Technical Service Information

CHRYSLER A404

SEVERELY DELAYED 1-2 UPSHIFT AFTER REVERSE

Figure 1

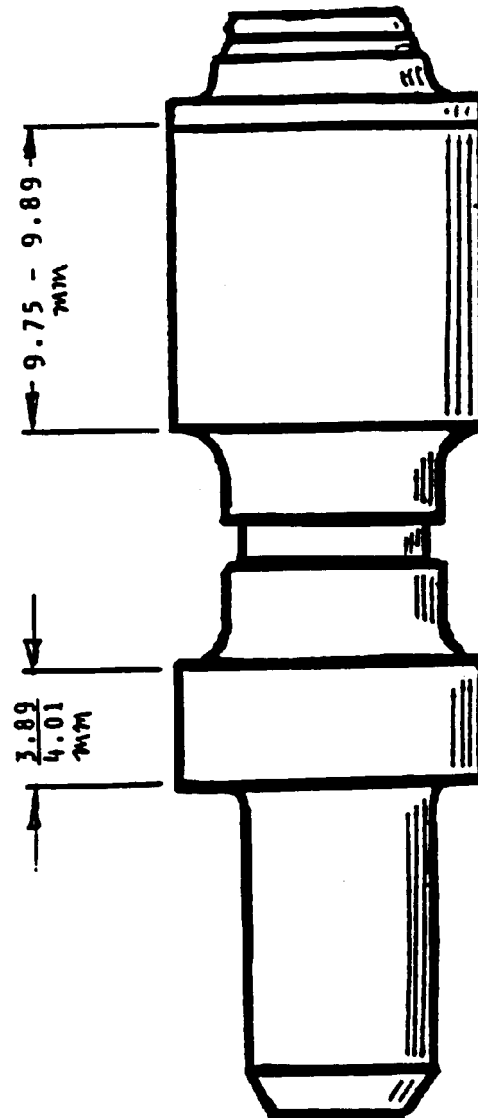
Customer concern of severely delayed 1-2 upshift after operating vehicle in reverse, particularly when transaxle is cold. The 1-2 upshift may not occur until vehicle has traveled as much as 1/4 of a mile and/or shift speed may be 10-12 MPH above normal shift speed range.

1. Remove Transaxle oil pan and allow to drain.
2. Remove Valve body.
3. Remove throttle valve from valve body. Check the lands for proper size on the valve as shown in figure 1. If the lands on the valve are short, replace the valve.
4. Reinstall the valve body and torque screws to 5 N.m (40 inch pounds).
5. Reinstall the transaxle oil pan and add the necessary fluid to bring to the proper fill level.
6. Road test vehicle for proper operation .

PARTS REQUIRED: 1- Throttle valve PN 4207230
